AR-001 Core and retained frame: structural coordination review

SIMULATED COORDINATION REVIEW CASE STUDY | NOT FOR CONSTRUCTION | 2026-09-13

AR-002 B2 wall joint and entry detailing screens

2F REFERENCE PLAN / 1:69

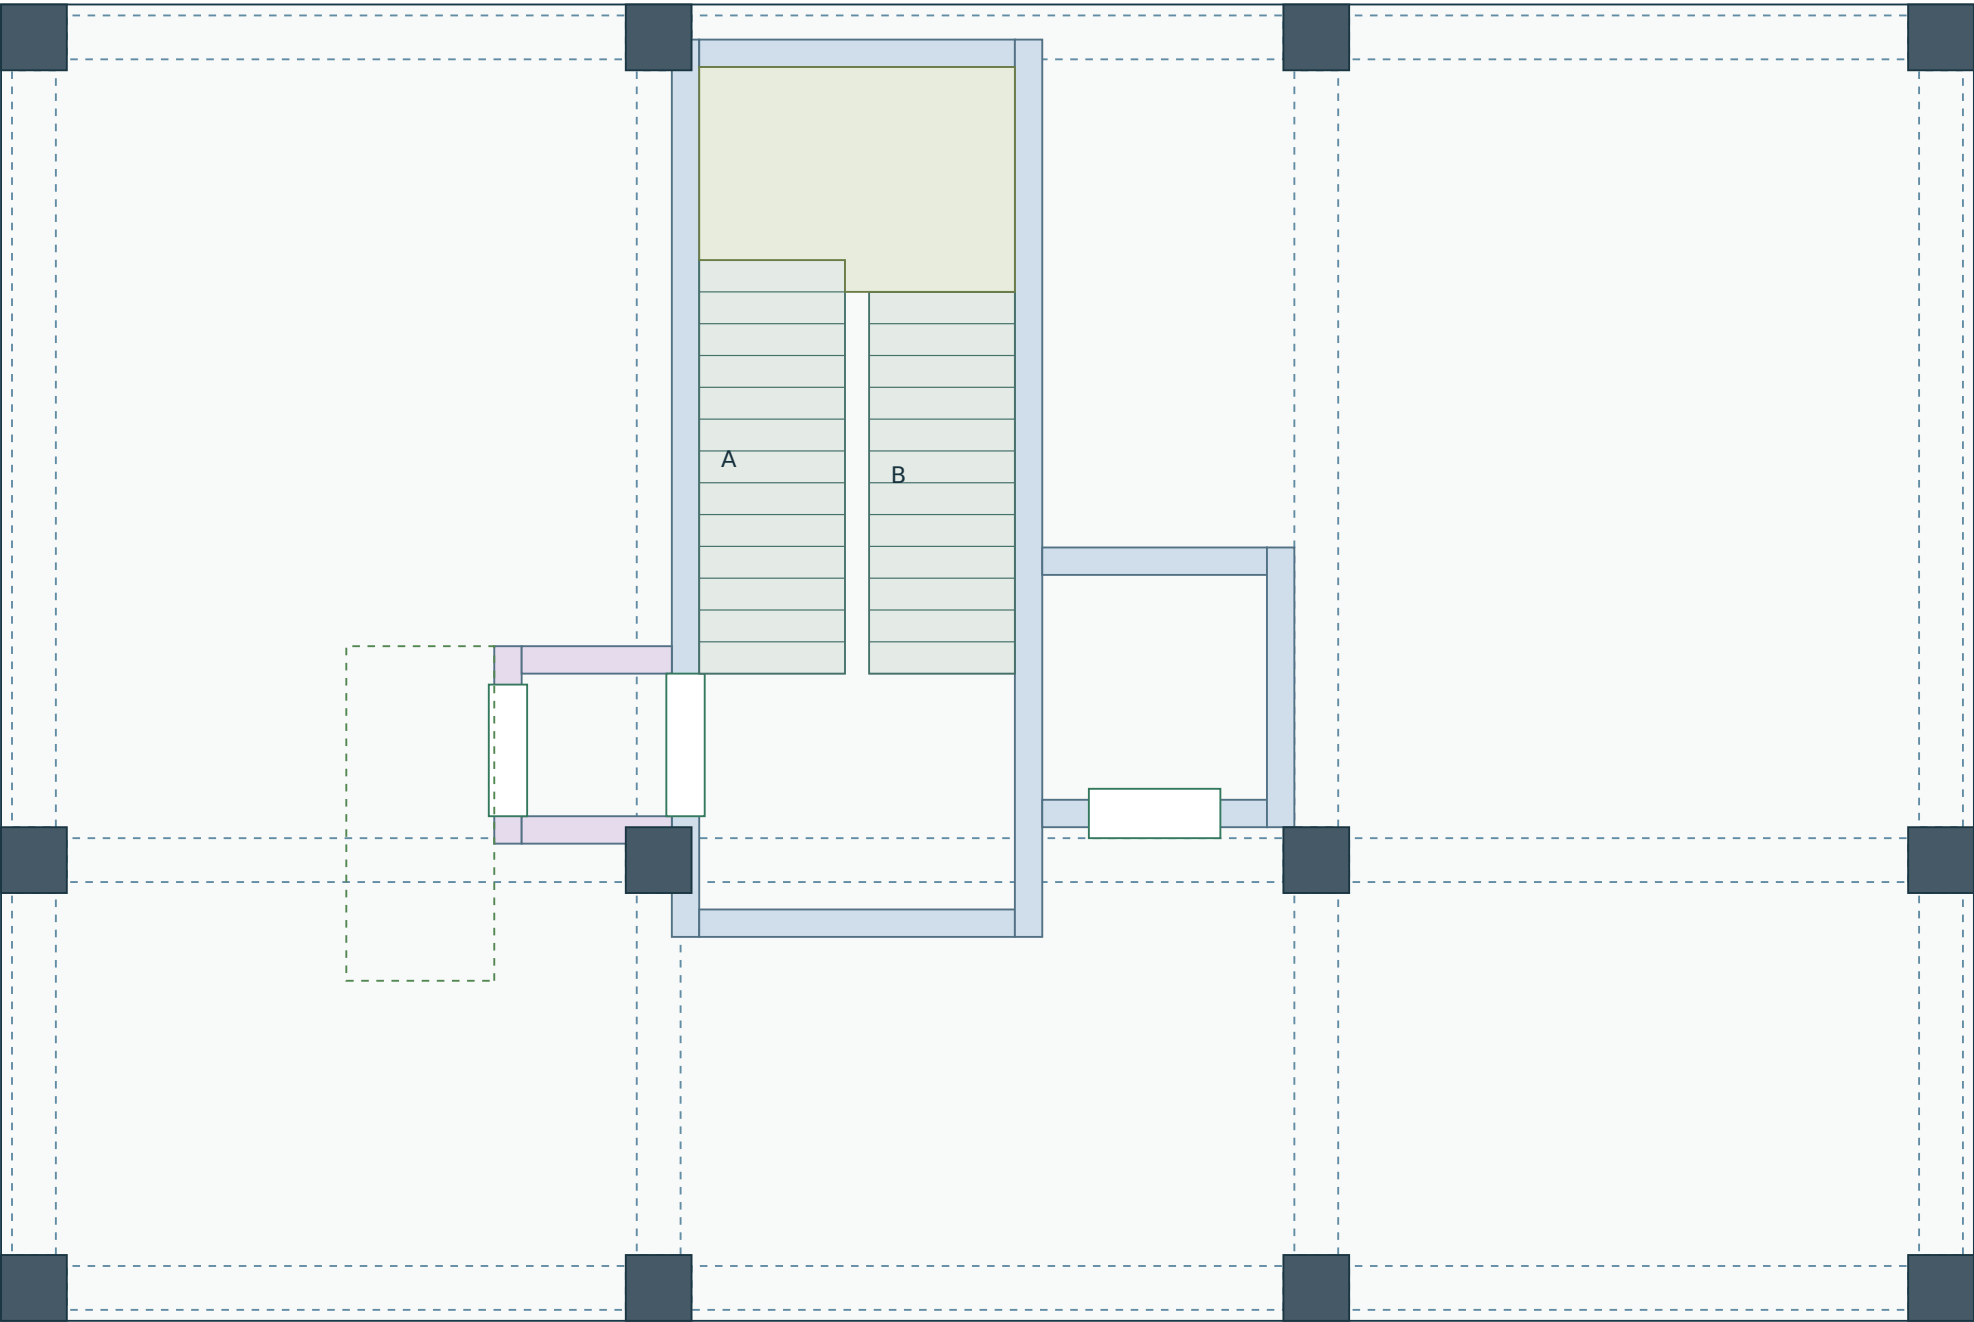
B2 clears the portal by 0.10 m in plan.

Actual finished throat: 1.28 m > target 1.20 m.

See AR-002 and SR-001/002 interface review.

Elastic joint action checked; RC design remains open.

No RC reinforcement or foundation approval.

This geometry matches the structural input. Architectural and construction acceptance are not complete.

1F PLAN DETAIL / 1:23.3

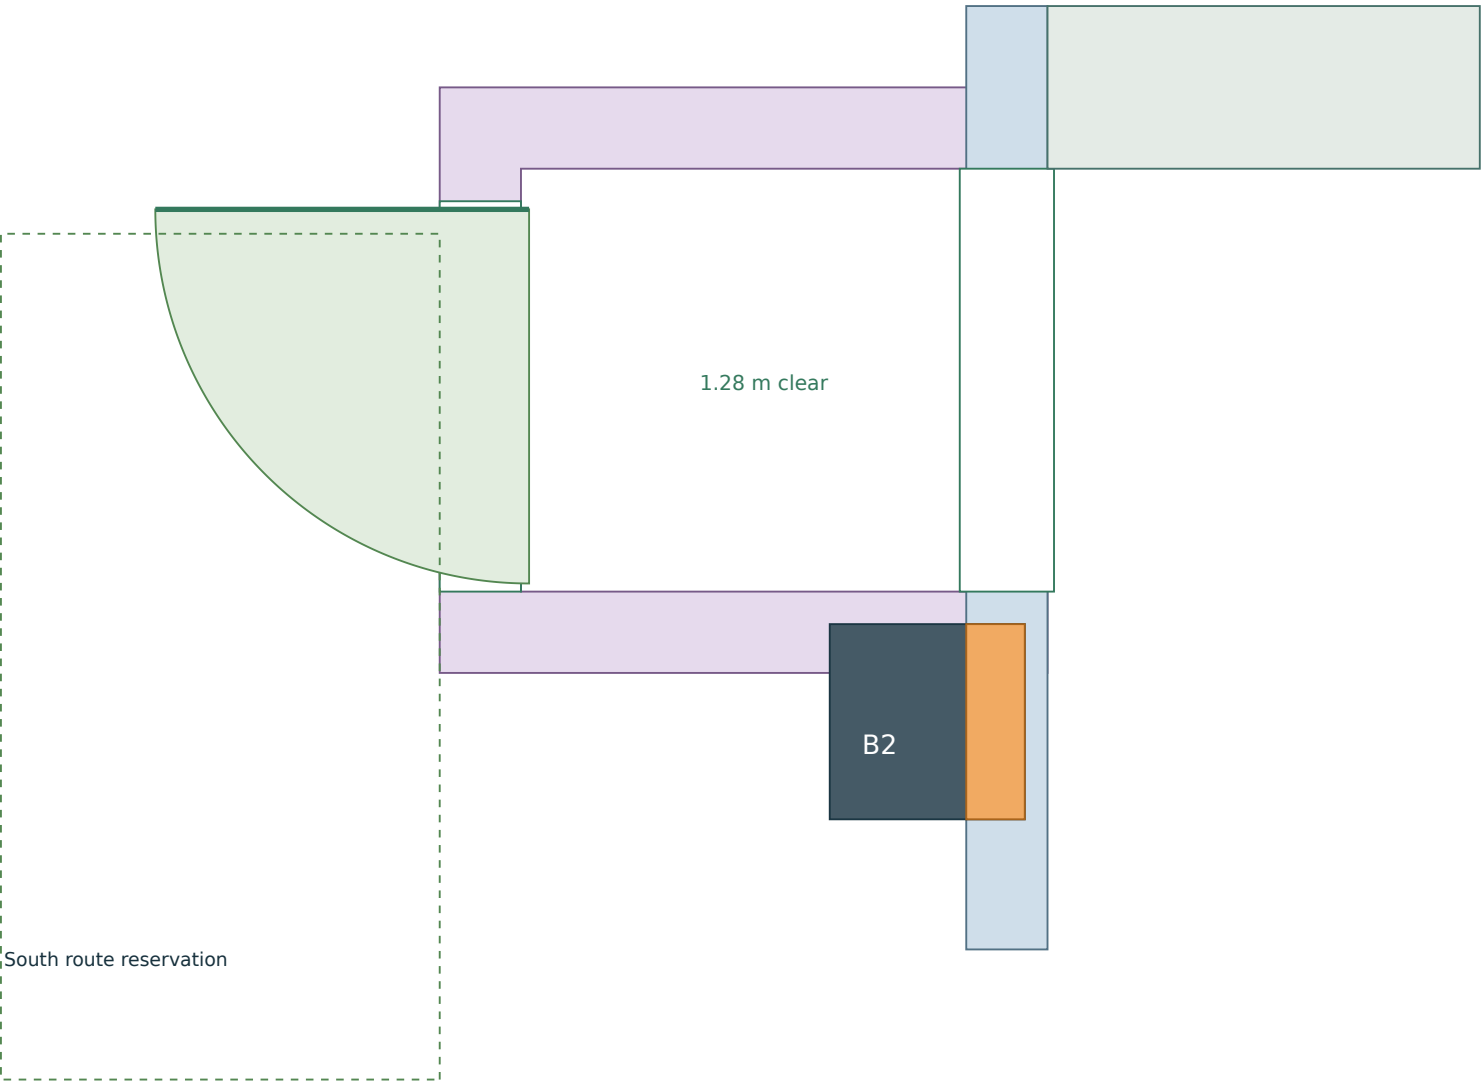
The portal clears B2. Wall-column elastic force transfer is modelled; joint reinforcement and full egress remain open.

Portal y = 4.60 to 5.90 m.

B2 column reaches y = 4.50 m.

Unobstructed raw interval = 4.60 to 5.90 m.

After two 10 mm finishes: 1.28 m.

Project passage target: 1.20 m. Nominal pass.

Ground top hinge opens west; full leaf is north of the reserved south route. Full egress is open.

Rated assemblies and all anchorage are unverified.

The 1.20 m target is a recorded project screen; this is not a complete statutory egress review.

Ground door and guard lines are geometric reservations; certified products and reinforcement are not designed.
